STATE OF CONNECTICUT  
CONNECTICUT SITING COUNCIL

PETITION NO. 1590

November 9, 2023

**RESPONSES OF TOWNORTH DEVELOPMENT, LLC AND NEW CINGULAR WIRELESS PCS, LLC TO CONNECTICUT SITING COUNCIL INTERROGATORIES**

SHEET TITLE  
 COMPOUND PLAN & ELEVATION

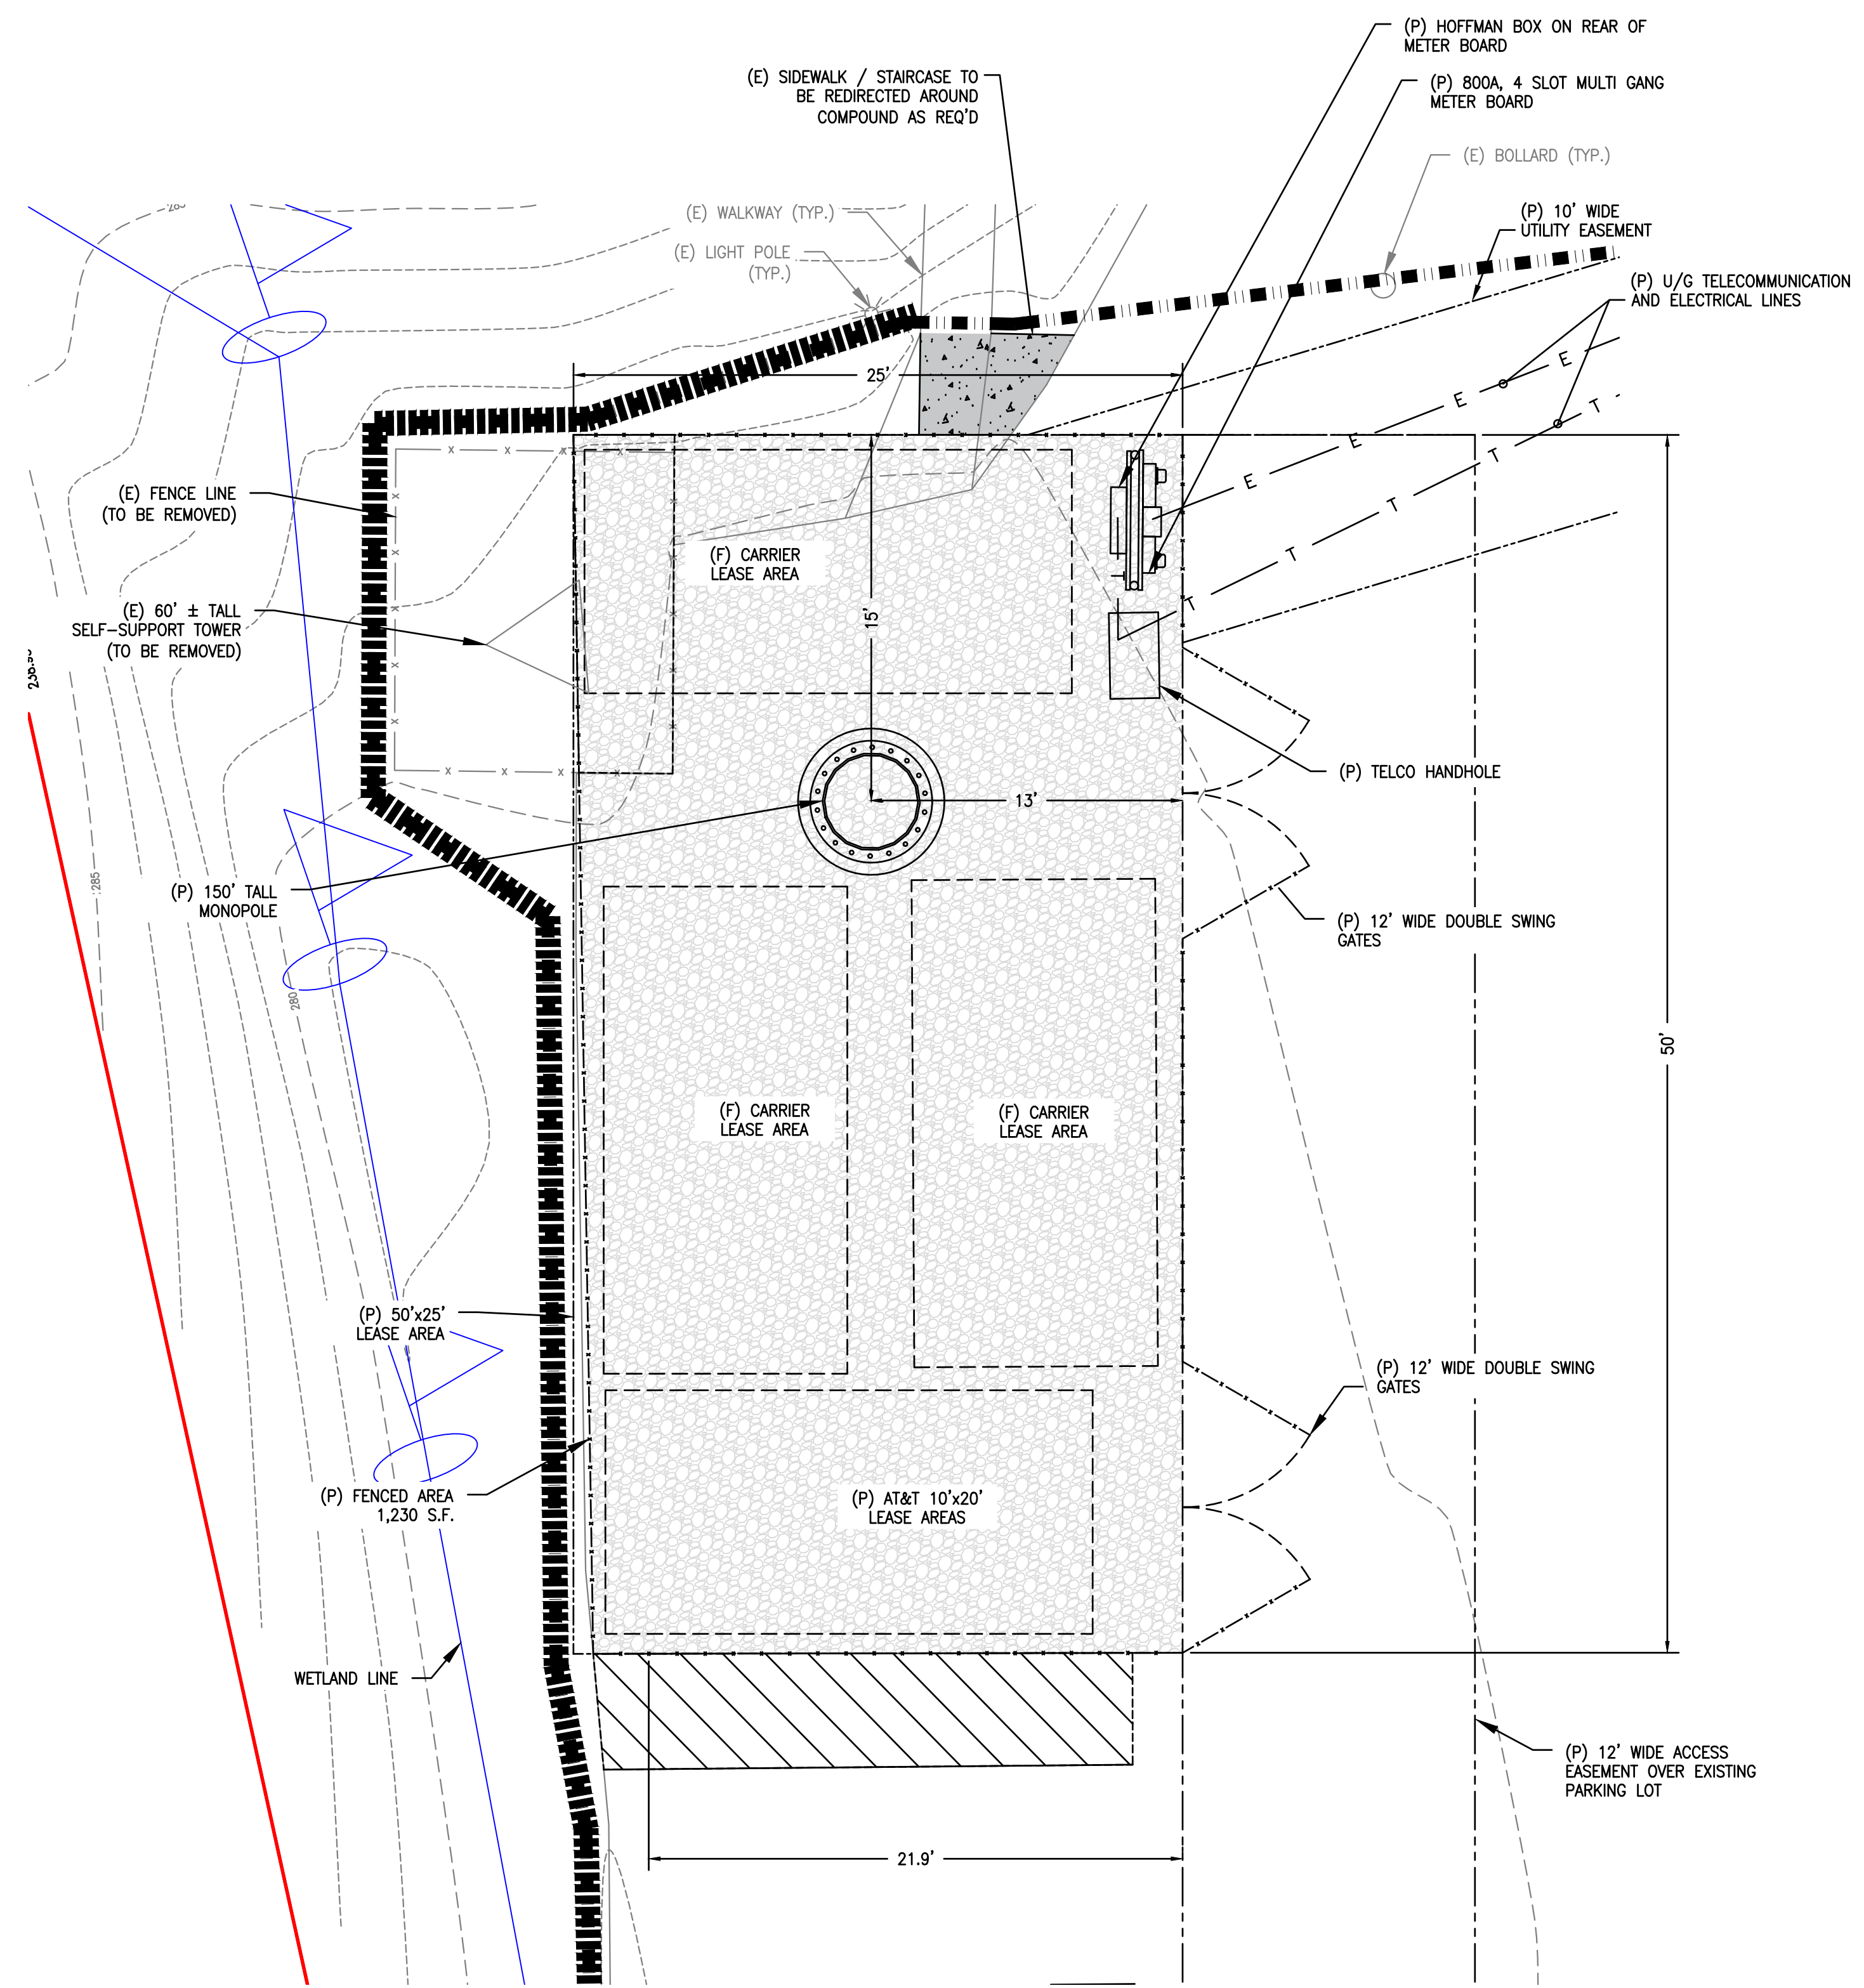
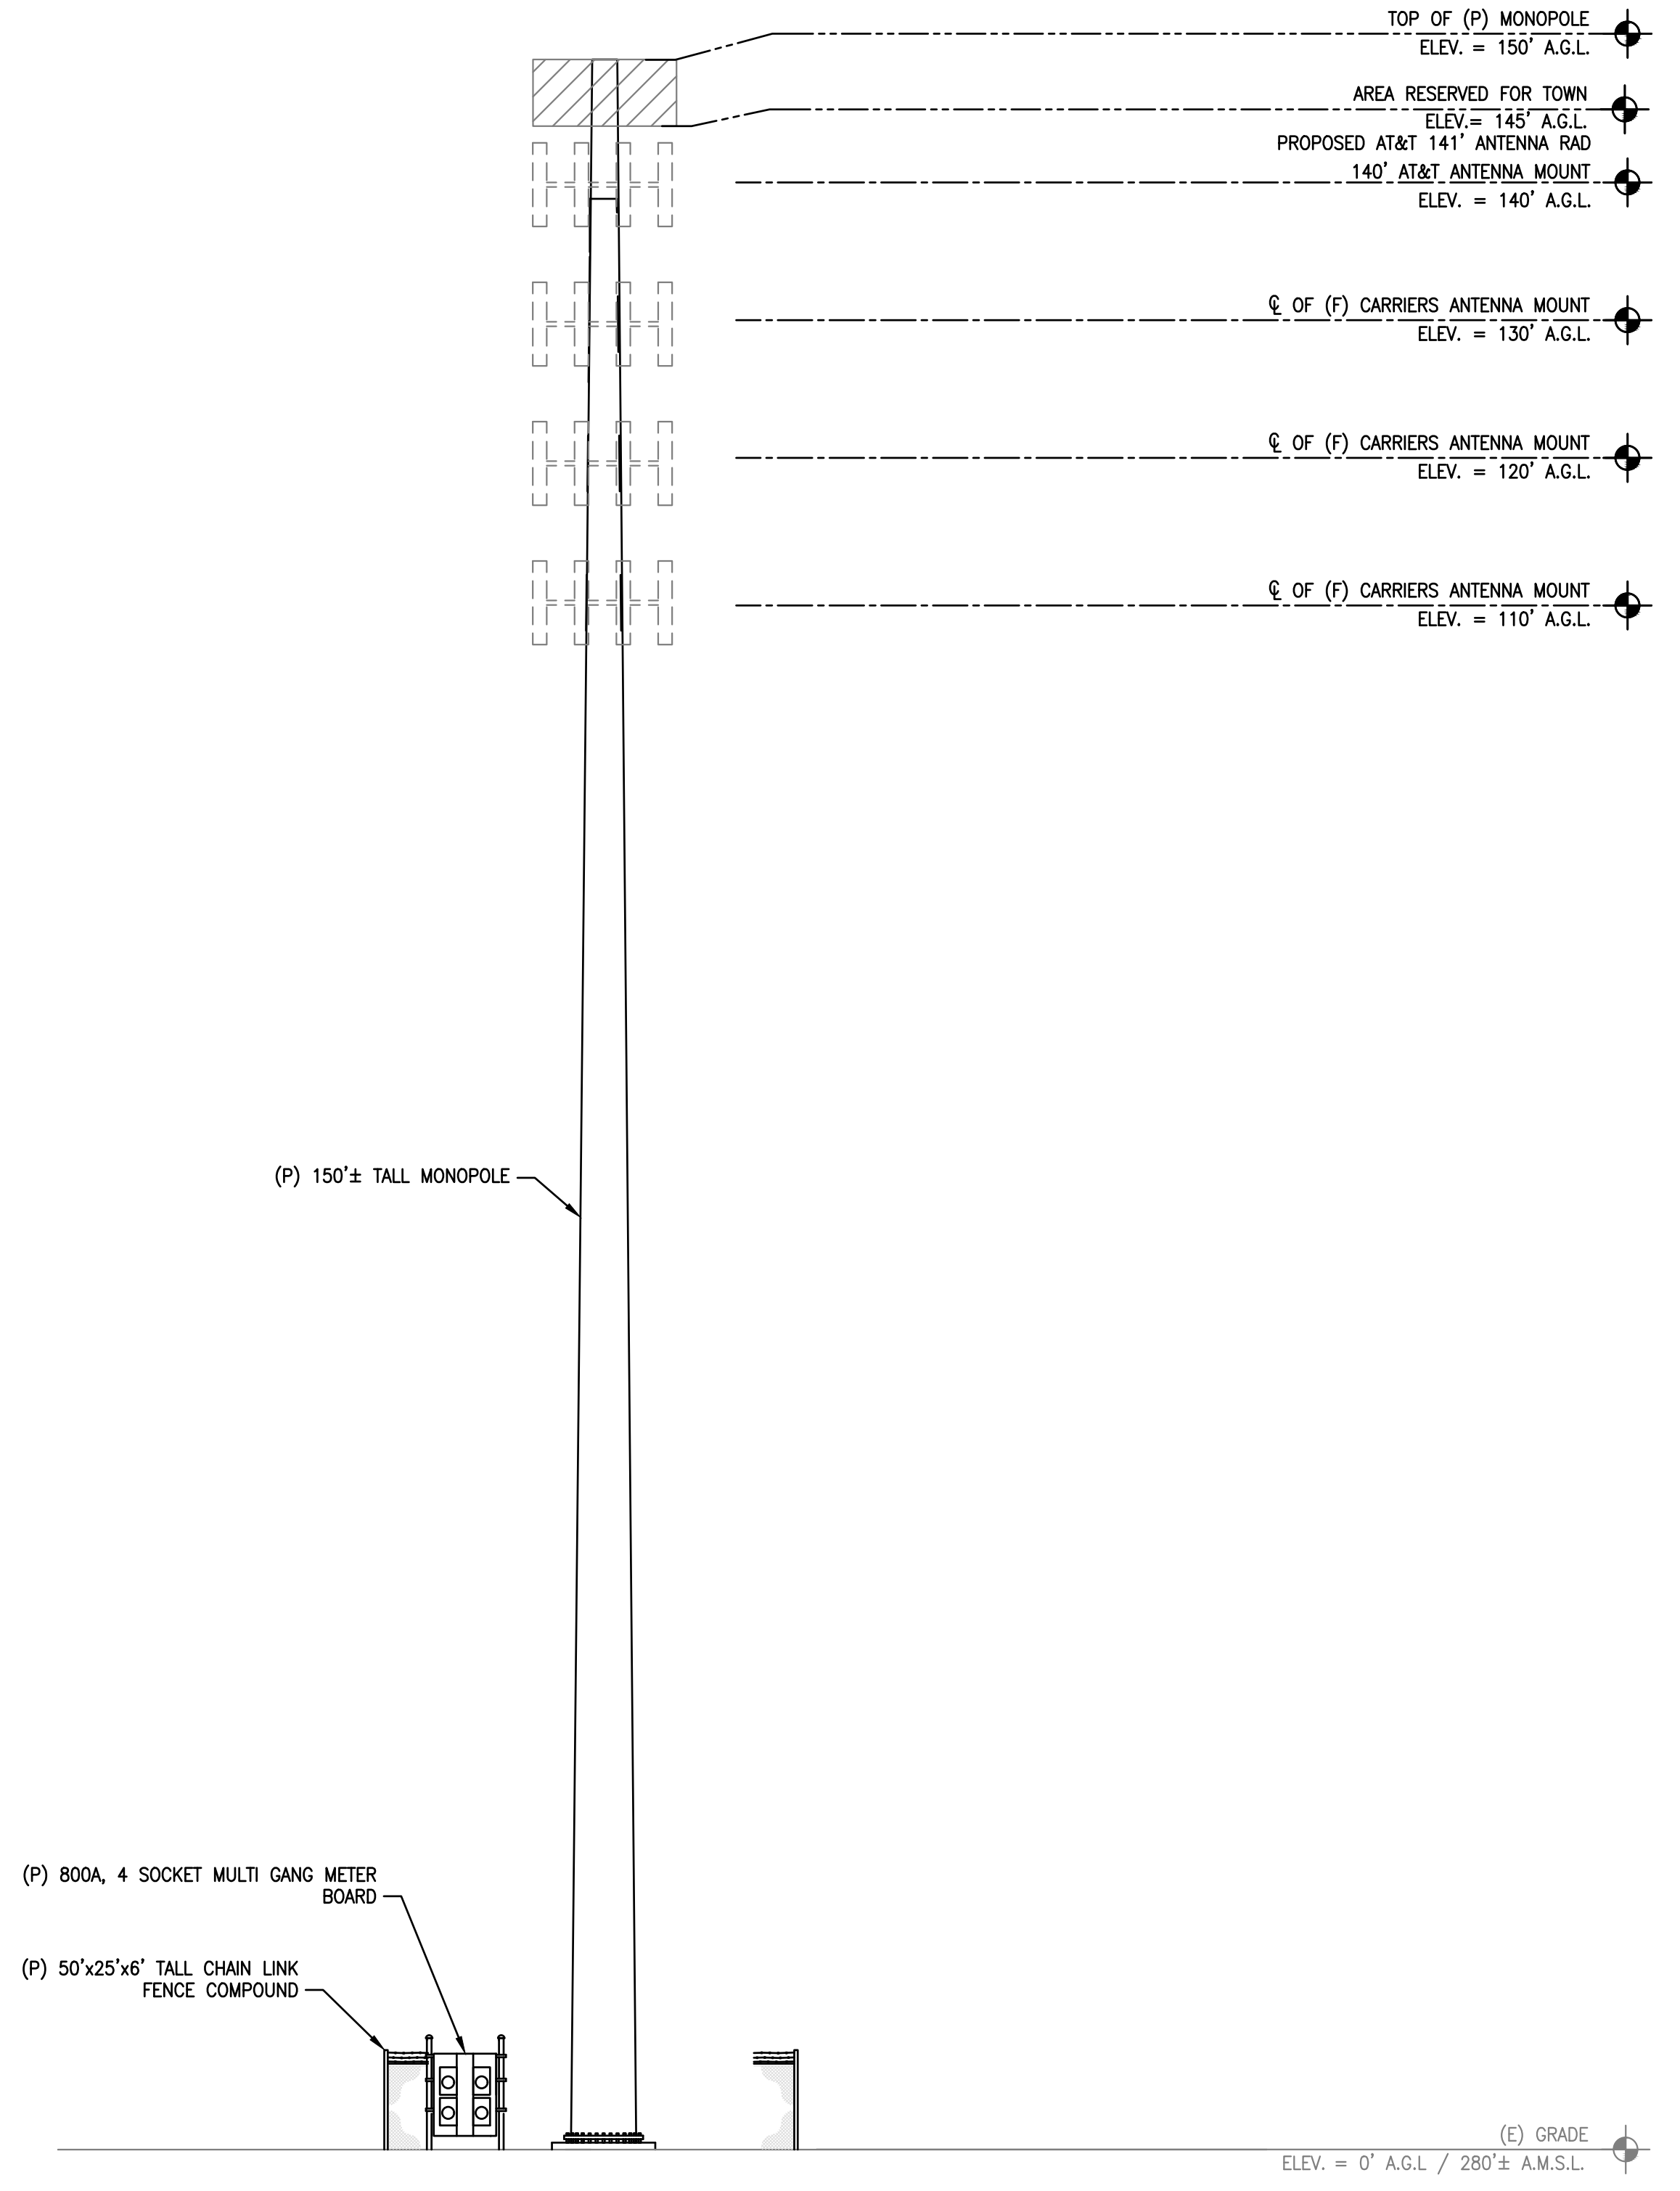
- Q24. Referring to Petition page 2, the fenced equipment compound would be 1,684 square feet. According to Sheet Z-1 of the site plan provided in Petition Attachment 2, the fenced compound dimensions would be 24 feet by 50 feet (1,200 square feet). Sheet Z-2 provided in Petition Attachment 2 shows the fenced compound as a 25-foot by 50-foot (1,250 square feet) area. Please clarify.

- A24. *The lease area will be 25'x50' (1,250sft) and the fenced compound will be approximately 1,230sft as the compound fence is not rectangular. The drawings were updated to clarify this item. The updated drawings are included in **Attachment 2**.*
